AS350 B3e FLIGHT MANUAL

RFM dated on 25/06/2024

REVISION TO AIRCRAFT PUBLICATION: AS350 B3e
PUBLICATION CONCERNED: FLIGHT MANUAL
CUSTOMIZATION AIRCRAFT:

Figure 2: GTN 650Xi installation synoptic

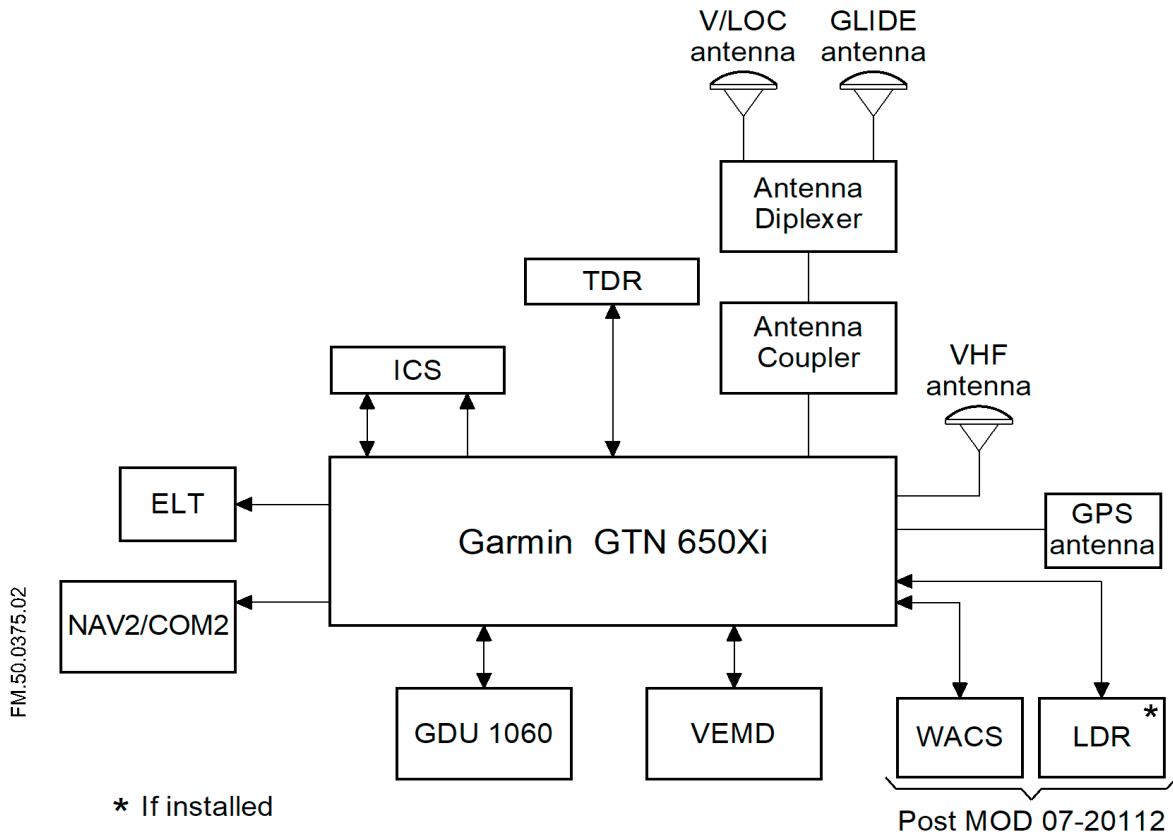
Replacement of "VOR/VHF GNC 255" by "NAV2/COM2" in the GTN 650Xi installation synoptic	SUP.55.9	2
Modification of NOTE 1 to integrate GTX 345R transponder	SUP.55.9	5
Update list of approved effective pages and log of approved normal revisions	SUP.55.10.P5	1 to 2
Suppression of : "x" appears in the heading display" in the symptoms of HDG FAIL message	SUP.55.10	7
Integration of "TRAFFIC" alert (Post MOD 07-20254)	SUP.55.10	8
Modification of title to integrate GTX 345R transponder	SUP.57.P1	1
Update list of approved effective pages and log of approved normal revisions	SUP.57.P5	1 to 2

Figure 1: GTX 335R/345R transponder with GTN 650 serie simplified diagram

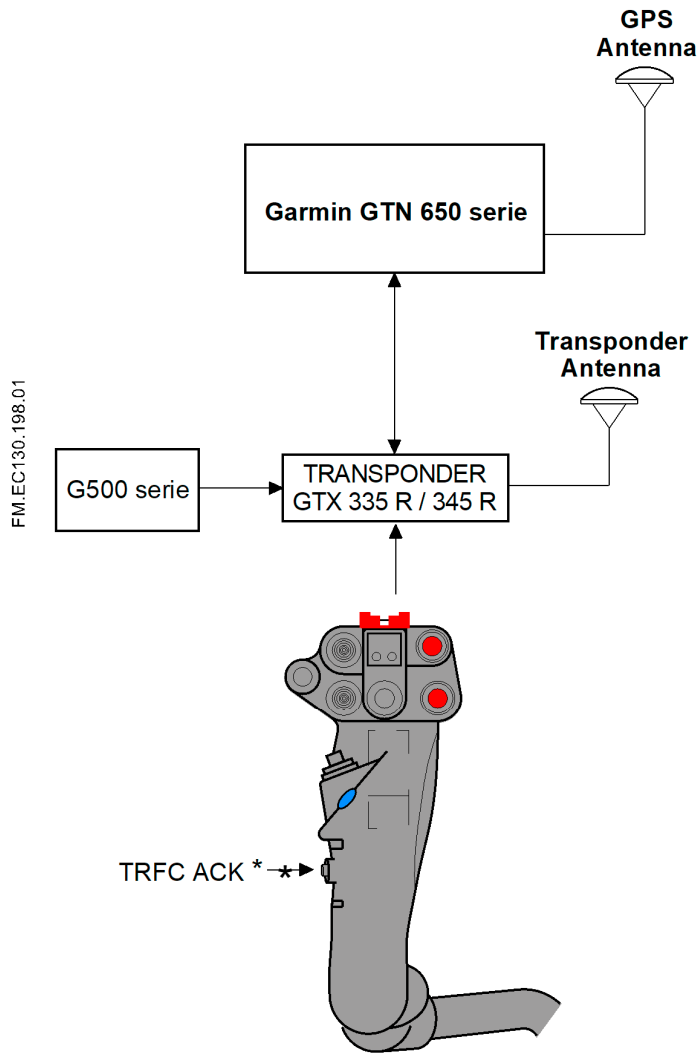
DESCRIPTION OF THE REVISION	Section	Page
- Addition of GTX 345R and push-button TRFC ACK in the diagram - Addition of "TRFC ACK" abbreviation (Post MOD 07-20254)	SUP.57	2
